MONTGOMERY COUNTY HISTORIC PRESERVATION COMMISSION
STAFF REPORT

Address:	6801 Westmoreland Ave.	Meeting Date:	04/19/17
Resource:	Contributing Resource Takoma Park Historic District	Report Date:	04/12/17
Applicant:	Mauricio Mateos	Public Notice:	04/05/17
Review:	HAWP	Tax Credit:	n/a
Case Number:	37/03-17BB	Staff:	Dan Bruechert
Proposal:	Rear addition, windows, siding, and other changes

Staff recommends that the HPC **approve with five (5) conditions** the HAWP application.

Proposed Front Elevation View
Scale 1/4"=1'

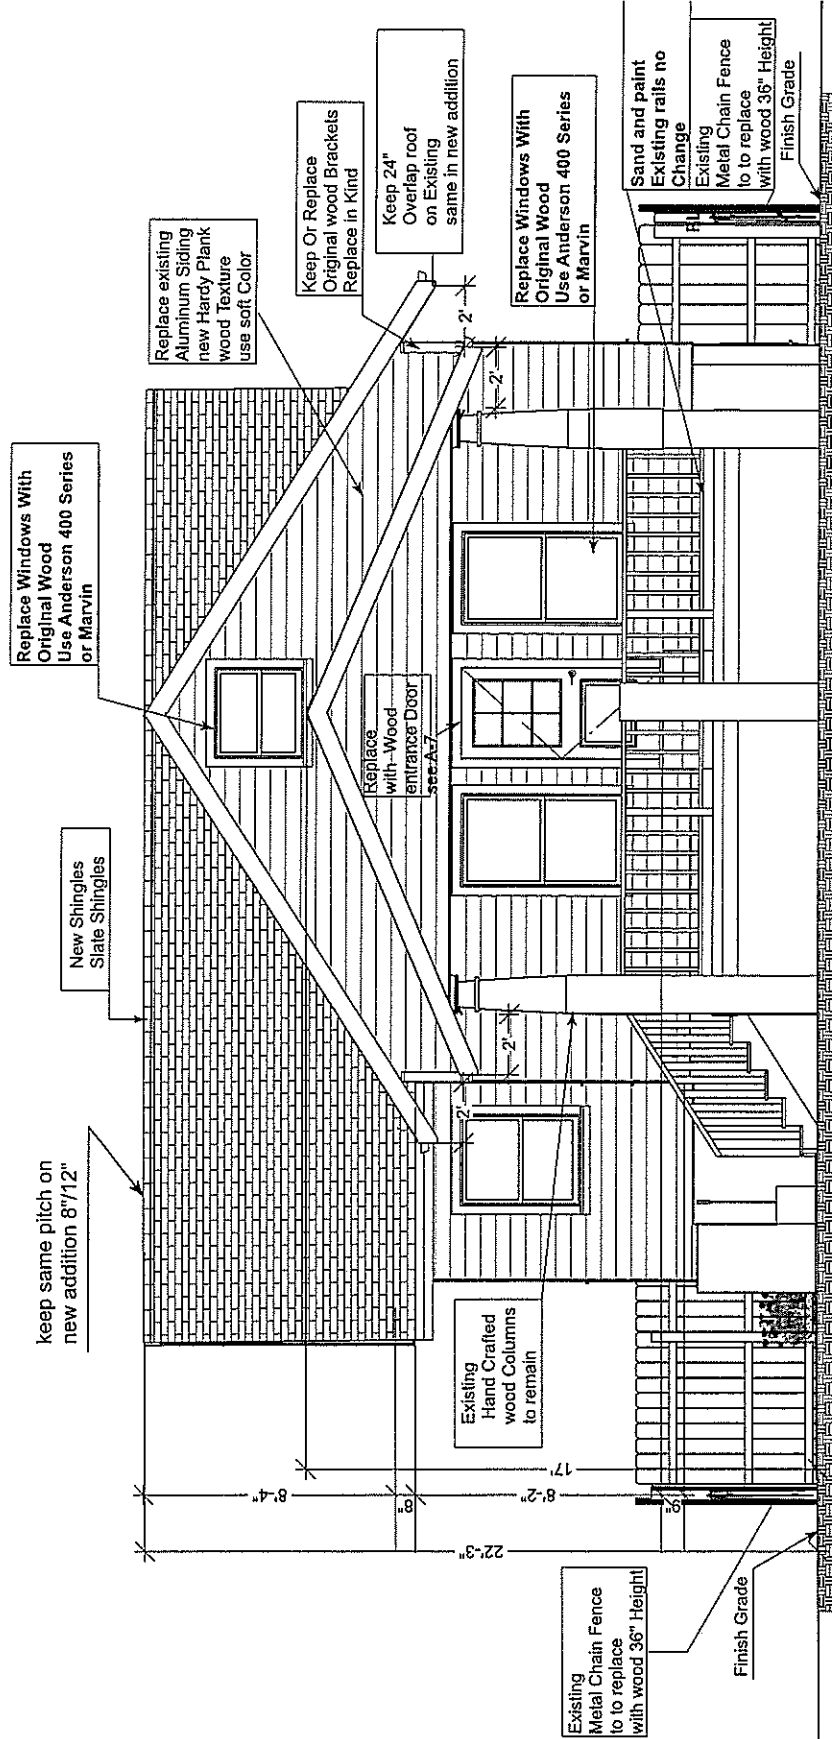
Existing Siding Aluminum no other siding installed under new proposed siding Hardie plank soft to compliance with Historic code al front windows side windows on existing structure will be the same size and original wood frame

front porch will remain exactly the same same pitch same wood just sand and Paint and millwork elements will be the same as existing noted the only change will be move the side stairs to the front it will be built treated wood, and shingle Replace

Front and Fence
wood Fence With Color
Replacing the existing
Metal chain fence

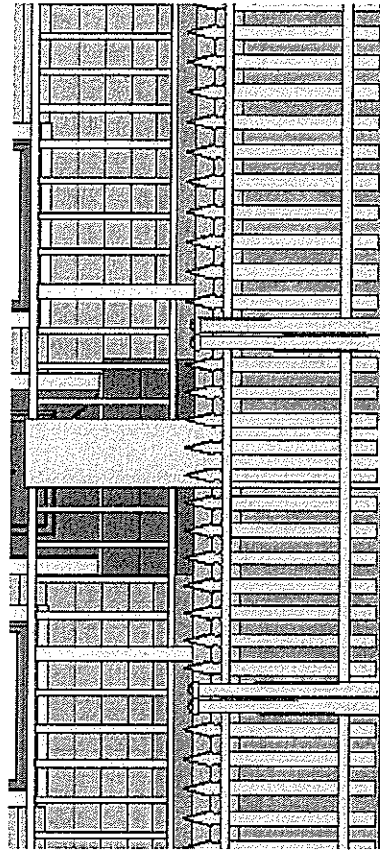
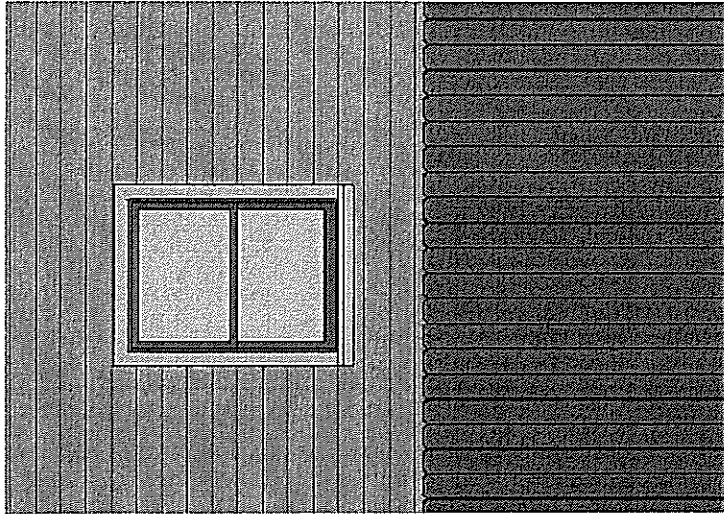
Finally, the applicant is proposing to replace the chain link fence surrounding the property. The proposal calls for the construction of a 6' (six foot) stockade fence to the rear of the property and a 36" (thirty-six inch) picket fence in front of the wall plane. Specifications for these fences has not been provided, however, their dimensions and materials generally comport with our fence guidance. Details, including gate access, for these fences must be submitted to staff for review and approval.

- Replacement windows need to be wood, not clad and specifications for the specific proposed windows needs to be submitted to Staff for review with authority for final approval delegated to Staff.
- Specification for the replacement wood front door must be submitted to Staff for review with authority for final approval delegated to Staff.
- Detailed dimensions for the picket and stockade fence must be submitted to Staff for review with final authority for final approval delegated to Staff.
- Detailed dimensions for the wood handrail at the front porch and iron and wood handrail to the basement entrance must be submitted to Staff for review with final authority for approval delegated to Staff.
- Shingle specifications for the addition and historic house must be submitted to Staff for review with final authority for approval delegated to Staff.
